23 July 2024 Reference: 240158.02FA

PRELIMINARY TRAFFIC AND PARKING ASSESSMENT OF THE PROPOSED MANUFACTURED HOME ESTATE AT 1064 NEW ENGLAND HIGHWAY, LOCHINVAR

ANNEXURE C: RECOMMENDED AND REQUIRED CHANGES (3 SHEETS)

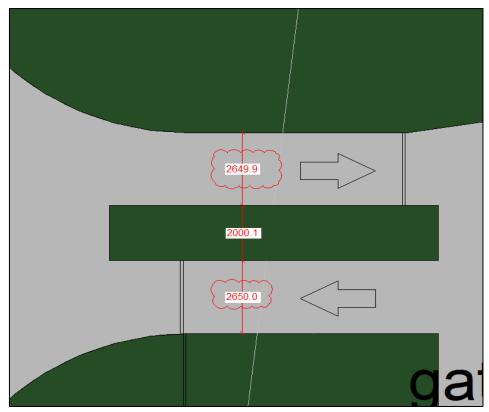
Minimum 3.5m circulation roadway required for MRV manoeuvring.

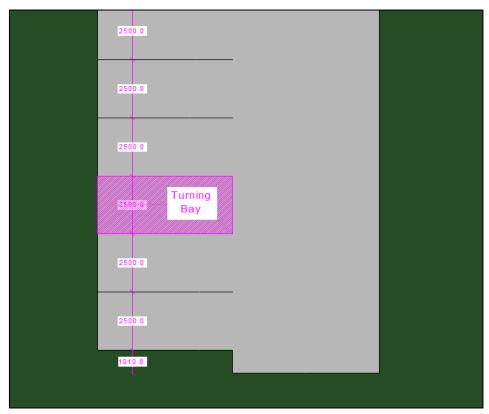
A turning bay is required for the 'Display Suite' car park. It is recommended that the space shown above is converted to a turning bay.

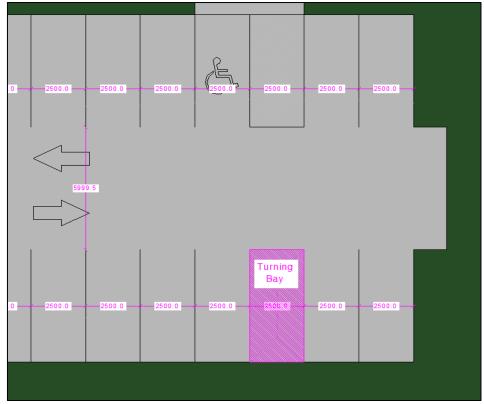
A turning bay is required for the Community Facility car park. It is recommended that the space shown above is converted to a turning bay.

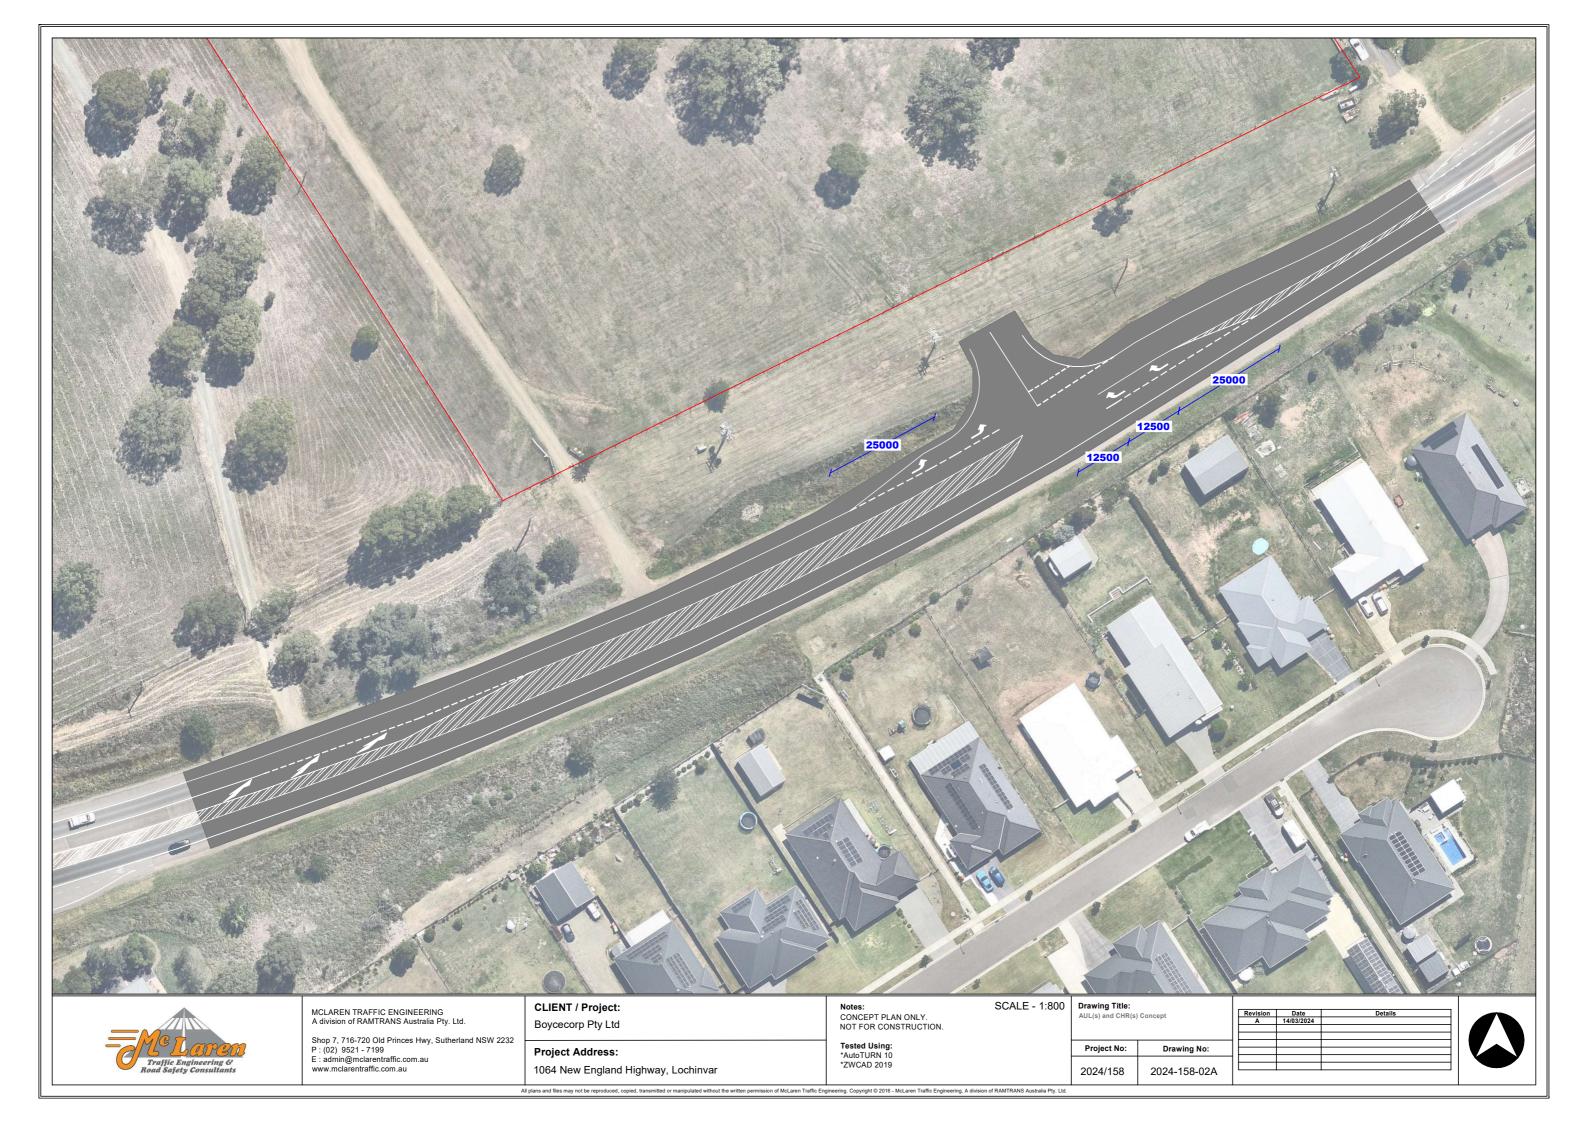
It is recommended that the internal circulation roadways adopt the proposed traffic flow. Further, it is recommended that linemarking is provided to discourage drivers from driving in the wrong direction.
